AGENDA CITY OF KENTWOOD PLANNING COMMISSION TUESDAY, OCTOBER 24, 2023 KENTWOOD COMMISSION CHAMBERS 4900 BRETON AVENUE, SE 7:00 P.M.

PROPOSED MINUTES OF THE REGULAR MEETING OF THE KENTWOOD PLANNING COMMISSION OCTOBER 10, 2023, 7:00 P.M. COMMISSION CHAMBERS

Kentwood Planning Department

C1 9/18/2023

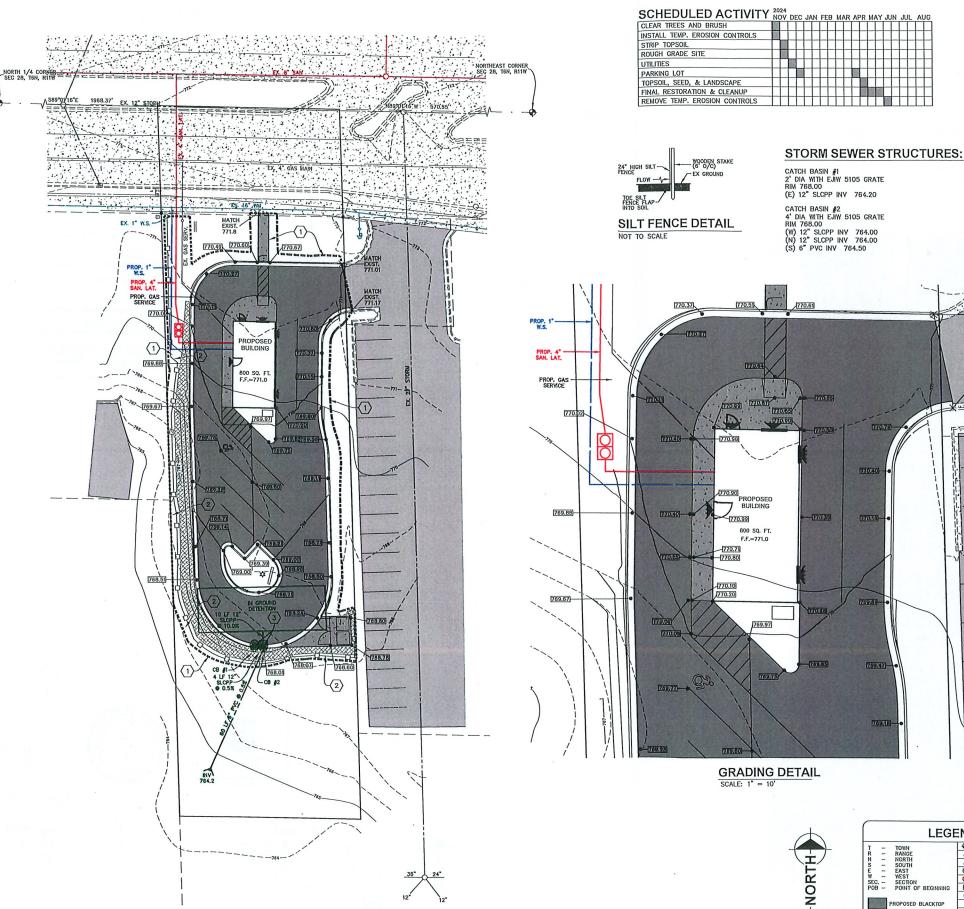
- 1. Sheet C1: Site Plan Key Notes: #4 provide a detail for the sidewalk construction.
- 2. Sheet C1: Site Plan Key Notes: #7 Provide a copy of the wetland permit when it is acquired.

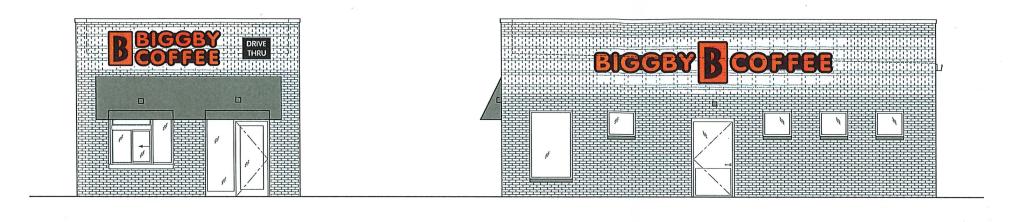
- 3. Sheet C2: The construction schedule is not accurate.
- 4. Sheet C2: Storm Sewer Structures The proposed outlet is 0.5' higher in elevation than the inlet pipes. Provide a detail for these structures. Also label these structures in the Plan View.

- 6. Sheet C2: The proposed sign will not be allowed in the _____ Street public right-of-way.
